Meeting:	Traffic Management Meeting	
Date:	28 February 2017	
Subject:	High Street, Henlow – Consider Objections to Parking Restriction Proposals	
Report of:	Paul Mason, Assistant Director Highways	
Summary:	This report seeks the approval of the Executive Member for Community Services for the implementation of waiting restrictions in High Street, Henlow

CENTRAL BEDFORDSHIRE COUNCIL PROPOSES TO INTRODUCE NO WAITING AT VARIOUS LOCATIONS IN HENLOW

Appendix B

High Street, Henlow (Town Farm Court to War Memorial)

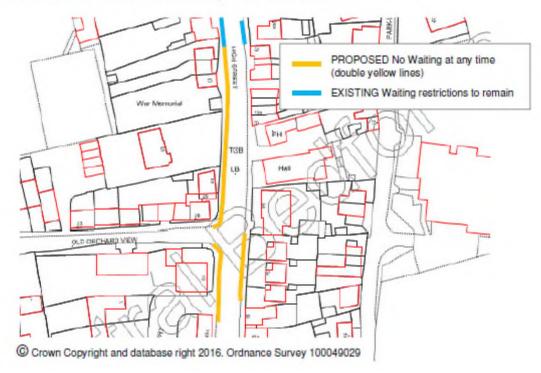
5 representations were received about the proposal to prohibit waiting near the junction of High Street and Town Farm Court. The main points are:-

- a) There is general support for the proposals, but that they should be extended slightly further south to improve visibility for emerging drivers.
- 9. Officer response:
 - a) Parking is heavy on this stretch of High Street and the restrictions have been kept to a minimum to maximise the number pf parking spaces. It is felt that the published restrictions offer a reasonable compromise between improving visibility for drivers emerging from Town Farm Court whilst retaining as much on-street parking as possible.

Can I suggest that as a Road Safety Measure, the No Waiting yellow lines be extended to a total of at least three car lengths beyond the north flank wall of 49c to give the residents at least a quick glimpse of vehicles travelling North.

It has become virtually impossible to see when exiting TFC due to inconsiderate parking close to both sides of our entrance. I speak for all residents of TFC by saying that I and they would also support the extending of the double yellows further southwards from the TFC entrance so that your item 9 reads '.... from a point approximately <u>10</u> metres south of the north flank wall of 49c High Street extending in a northerly direction'

High Street, Henlow (The Limes and Old Barn Close)

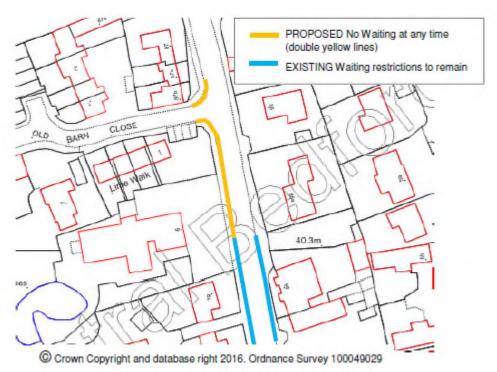
2 representations were received about the proposal to prohibit waiting near the junction of High Street and Town Farm Court. The main points are:-

- a) Parking has increased on the east side of High Street opposite The Limes residential home and sometimes cars block driveways. The area is also used for parking by large vans which obstruct visibility for residents exiting their driveways.
- b) The published proposal will mean that more vehicles will be parked on that side, so restrictions should be introduced on the east side as well.
- 11. Officer response:
 - a) Parking does take place on the east side of High Street, but the road widens slightly at that point, so is a reasonable place for vehicles to be parked. It is understood that residents on that side of the road have applied for H bar driveway protection markings which should help.
 - b) It is felt that parking can be safely accommodated on the east side and the removal of parking on that side would lead to migration of parking to less suitable lengths of High Street.

My feeling is therefore that if there are to be any yellow lines they should either be marked on both sides of the High Street from the southern boundary of my property (86A) or at least on the east side which has the worst problem with parking. I wonder if this problem has been looked at and observed at different times of the day on different days of the week. Often there are works vans parked from Friday evening until Monday morning so that I am unable to see safely to exit my drive for 2 full days and nights.

These restrictions do not go far enough. The restrictions need to be on both sides of the road.
